Product Change Notification

113851 - 00

Change Notification #: 113851 - 00
Change Title: Intel® Server Chassis P4308XXMHGC
PCN 113851-00, Product Design, Label
Update 750W Common Redundant Power
Supply FXX750PCRPS Firmware, Update
the Safety & Regulatory labels, Update the
Front Panel Printed Circuit Board and Power
Button LED and Change Capacitor and
Cable
Date of Publication: May 15, 2015

Figure-1: Pre-Change

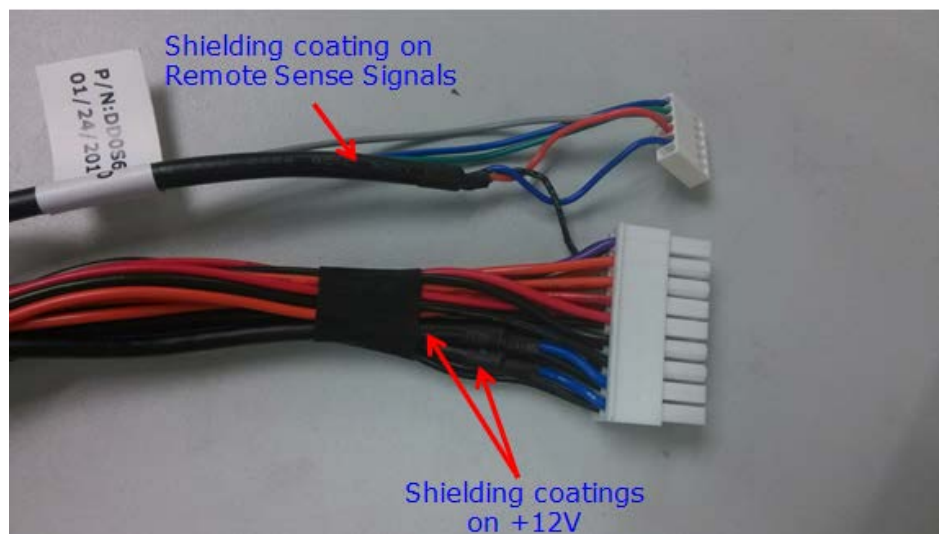
2. Update the Safety Label: Put an EAC logo instead of a GOST logo for certification update. Please see Figure-1 and Figure-2 below for details.
